A318/A319/A320/A321

TITLE : AIR CONDITIONING - AVIONICS EQUIPMENT GROUND COOLING - DEACTIVATE THE
GROUND REFRIGERATION UNIT (GRU).

MODIFICATION No. : 33129P8139

SERVICE BULLETIN No. : A320-21-1148

Figure 1 Sheet 1
Location of the Equipment

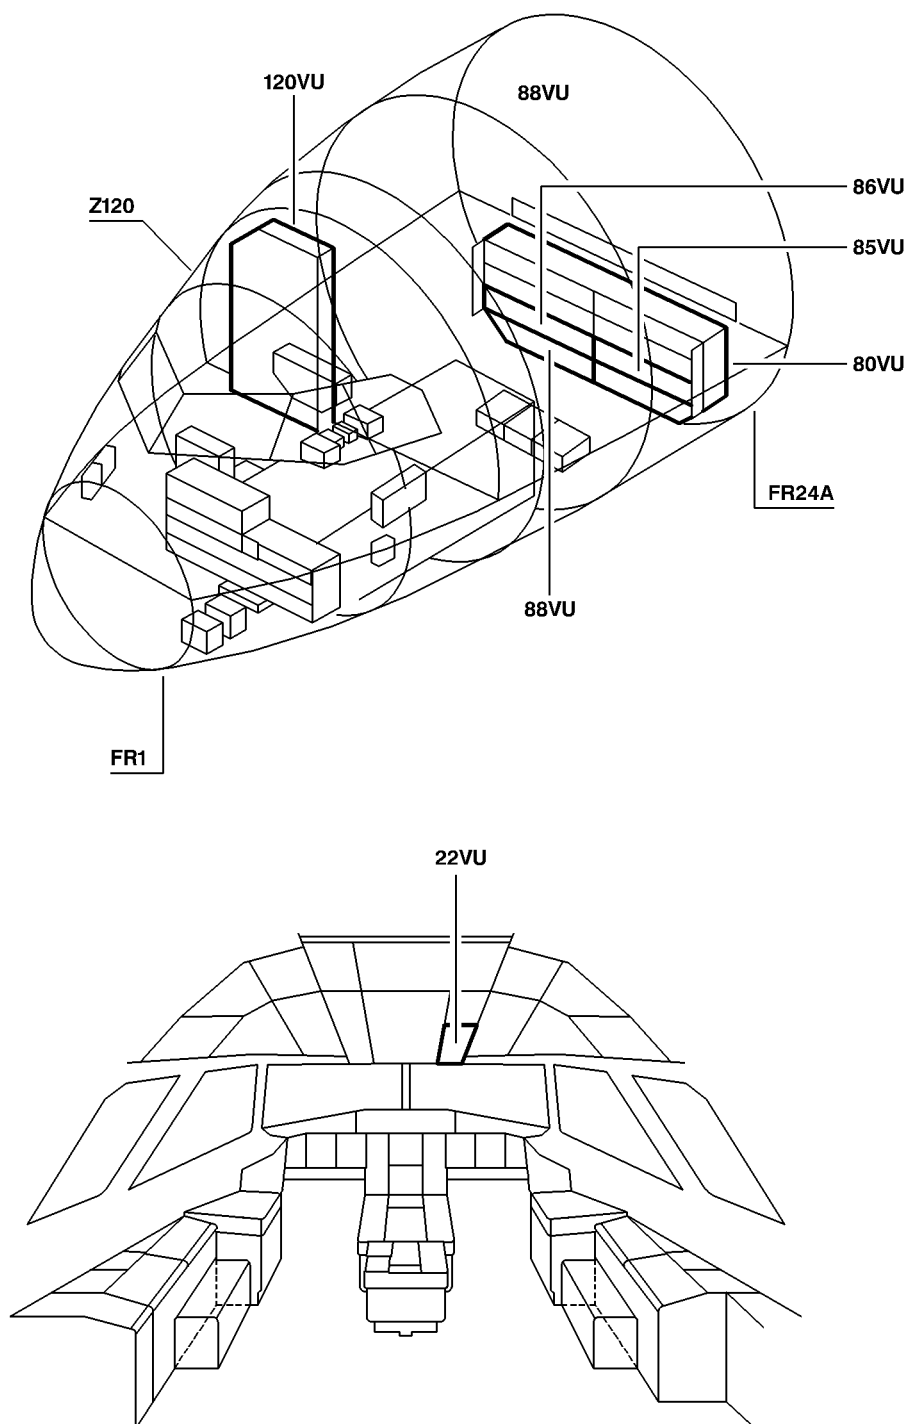
Refer to figure 1 Sheet 1

1 Modify the connection of the wires shown on the lines 1 thru 8 (Refer to figure 18).

Figure 1 Sheet 2
Location of the Equipment

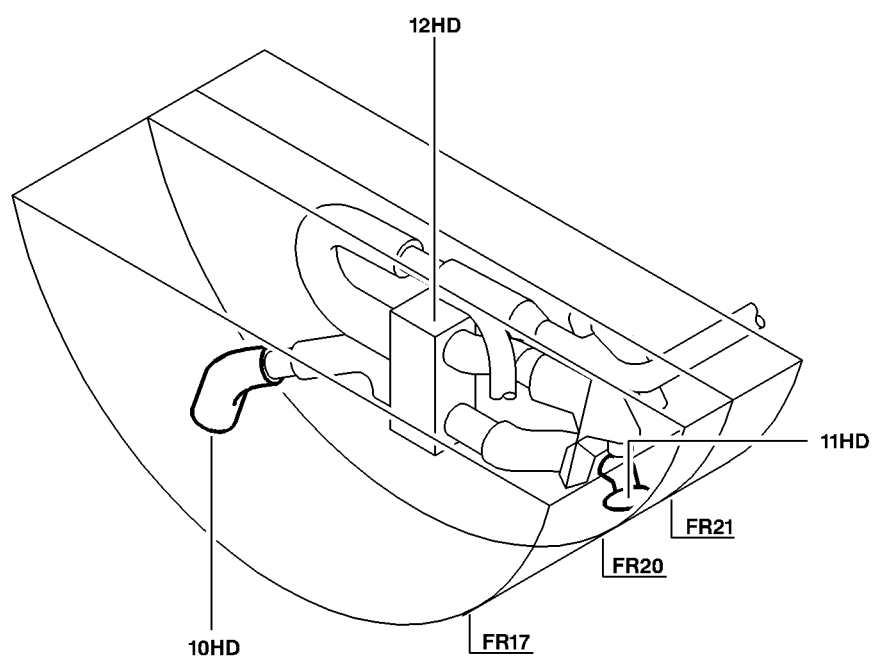
Refer to figure 1 Sheet 2

Figure 2 Sheet 2
Modification of the Inlet Skin Air valve (11HD)

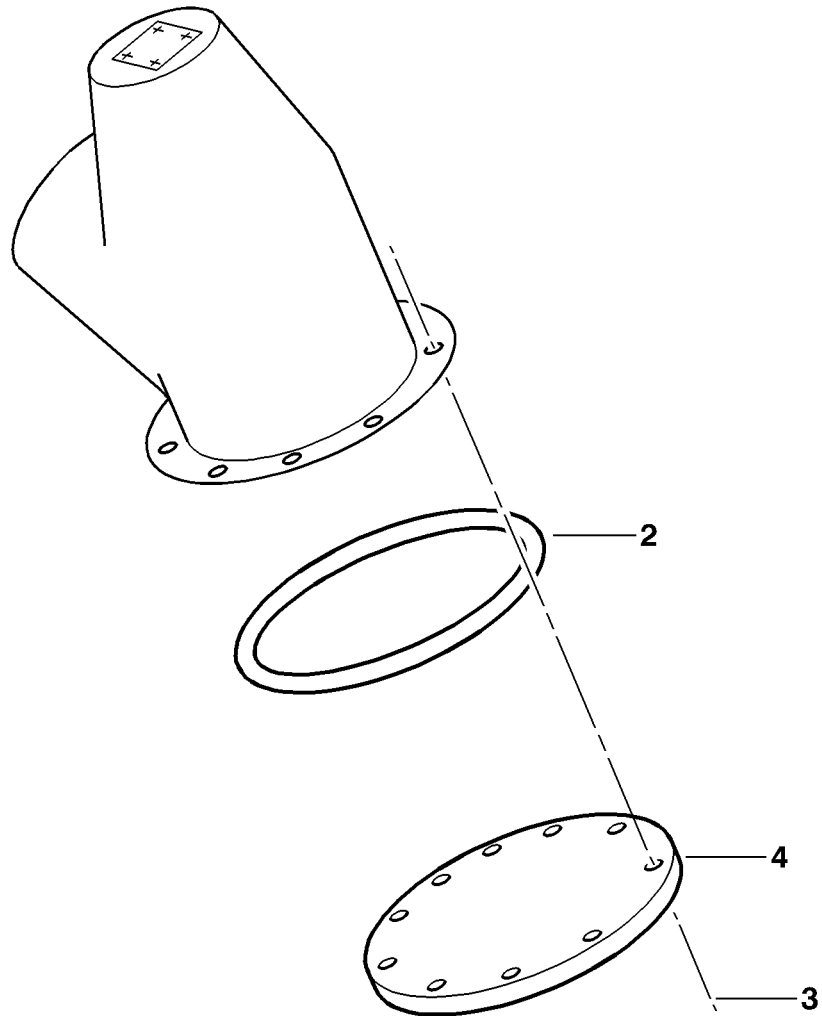
Refer to figure 2 Sheet 2

Figure 3 Sheet 1
Modification of the Plug on the Bench

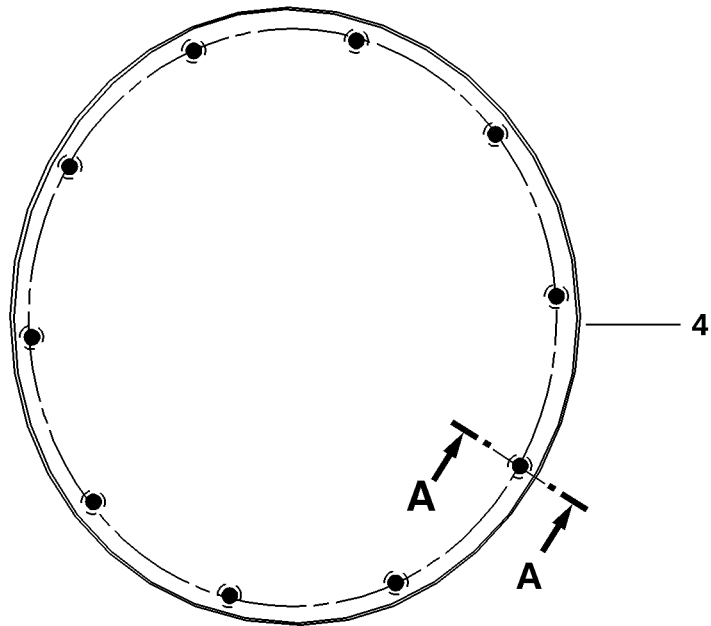
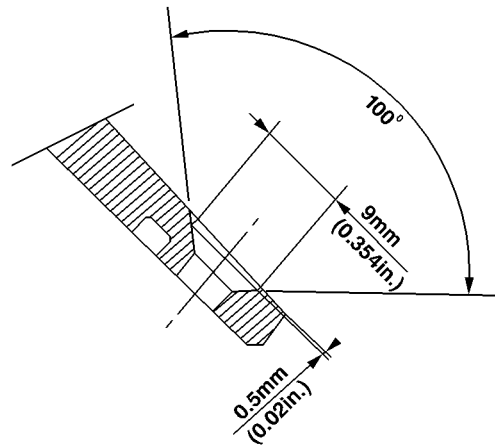
d Drill the plug item 4 to match the ten holes, (Refer to figure 3).

d Drill the plug item 4 to match the ten holes, (Refer to
figure 3).

Figure 4 Sheet 2
Modification of the Routing in the LH FWD Avionics Compartment

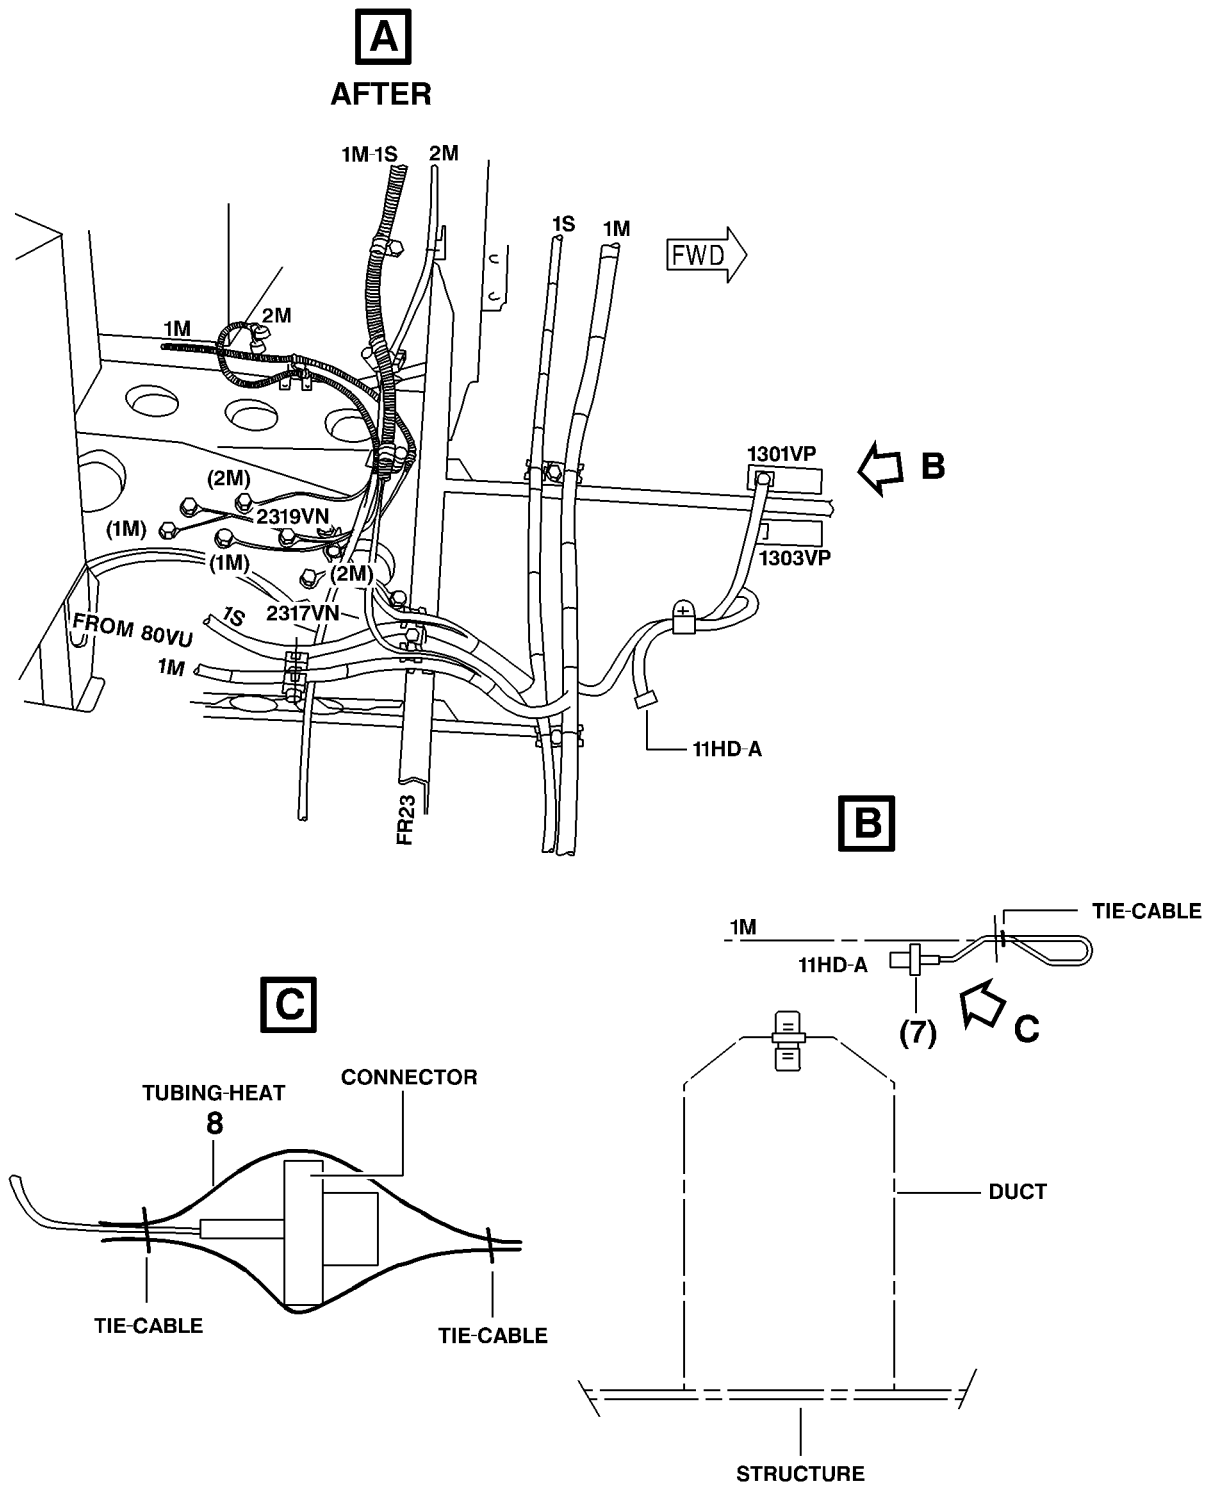
Refer to figure 4 Sheet 2

Figure 5 Sheet 1
Modification of the Outlet Skin Air Valve (10HD)

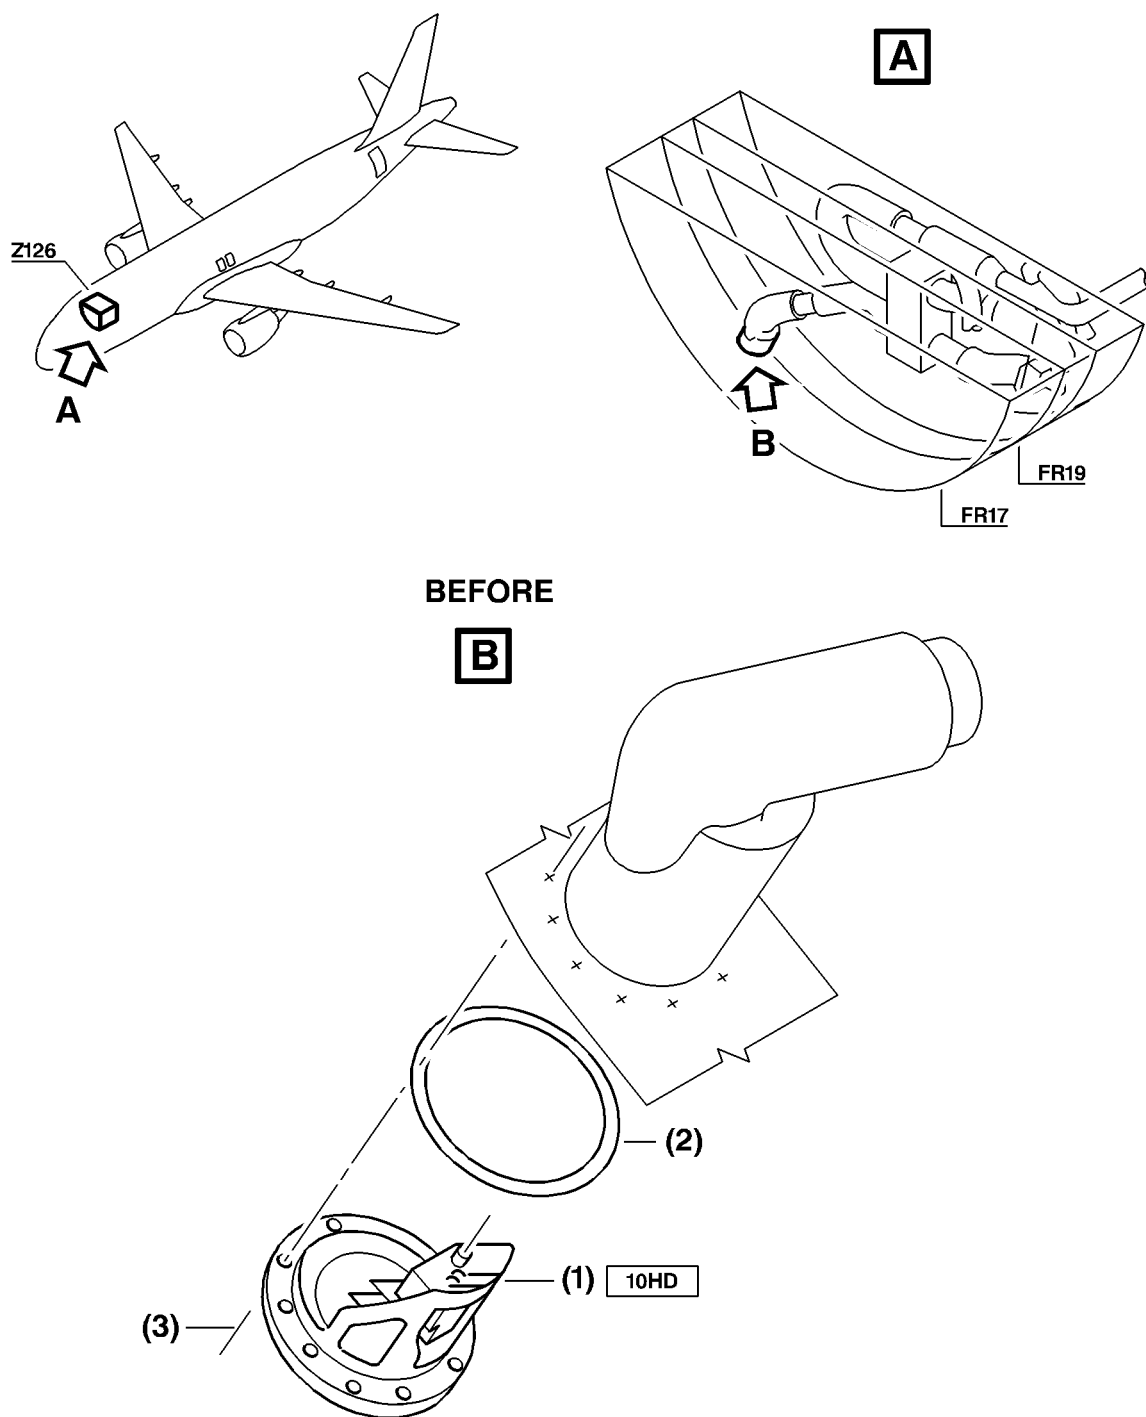
c Remove the outlet skin air valve (10HD) item (1) and
discard it.

Figure 6 Sheet 1
Modification of the Routing in the RH Avionics Compartment

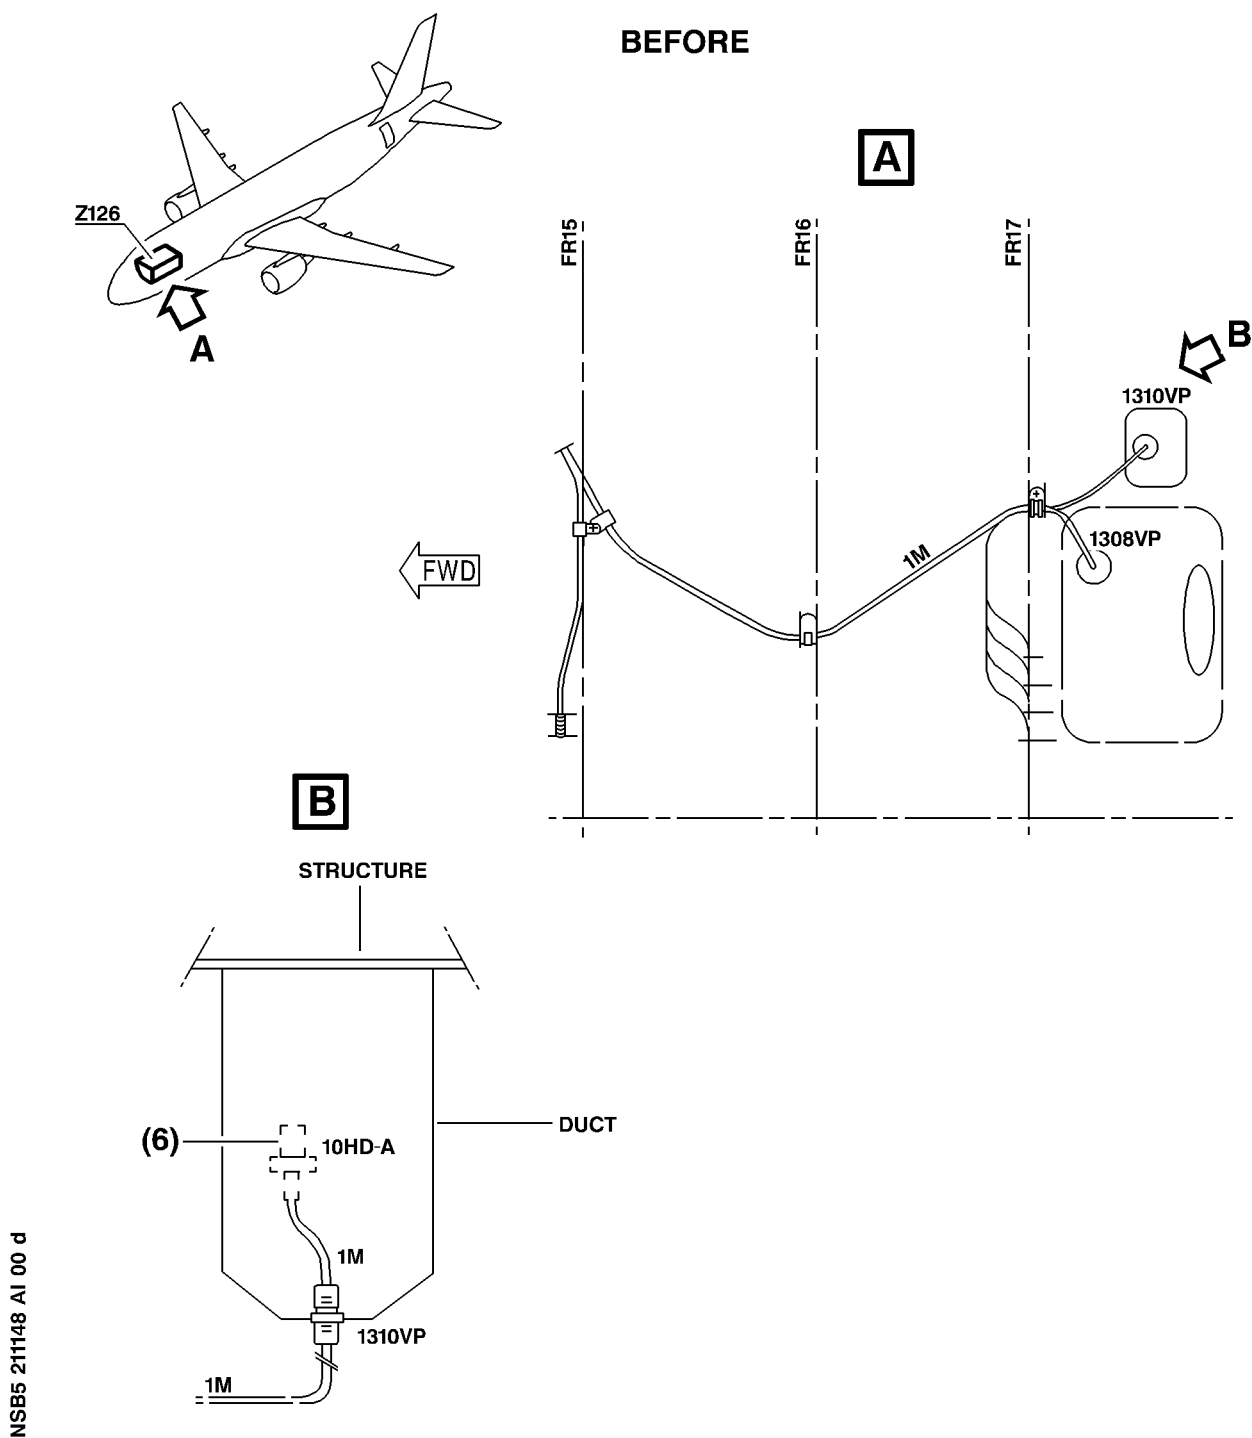
Refer to figure 6 Sheets 1 and 2

Figure 6 Sheet 2
Modification of the Routing in the RH Avionics Compartment

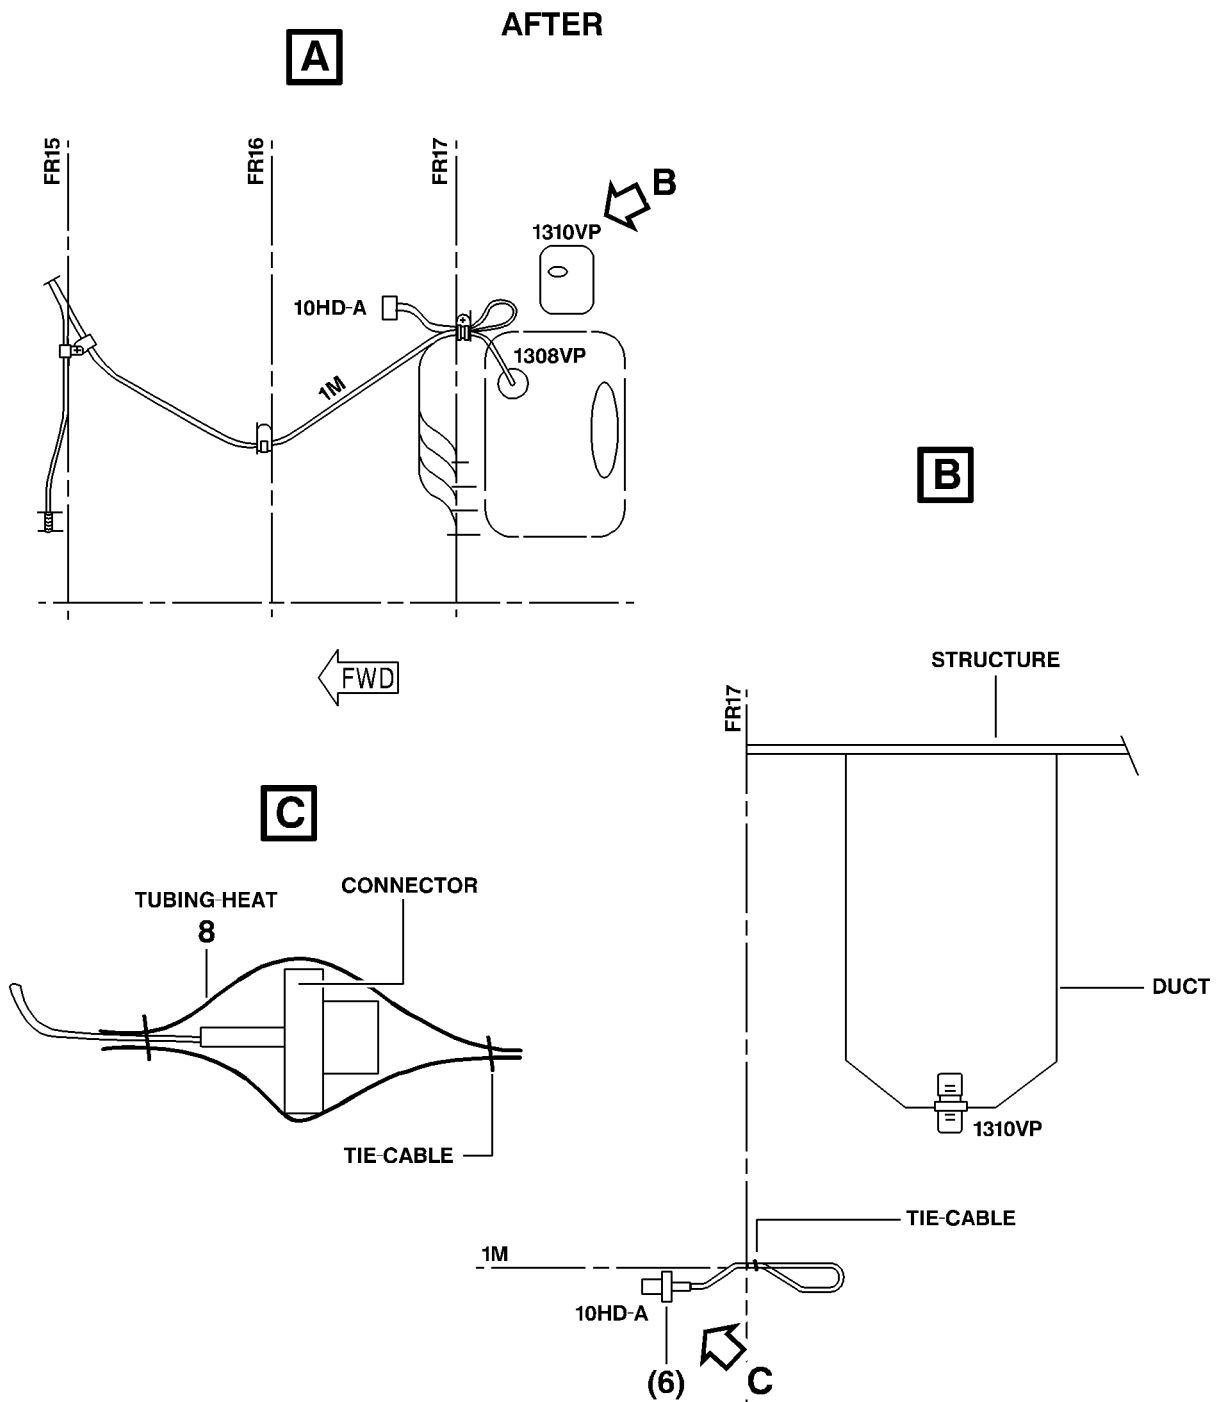
Refer to figure 6 Sheet 2
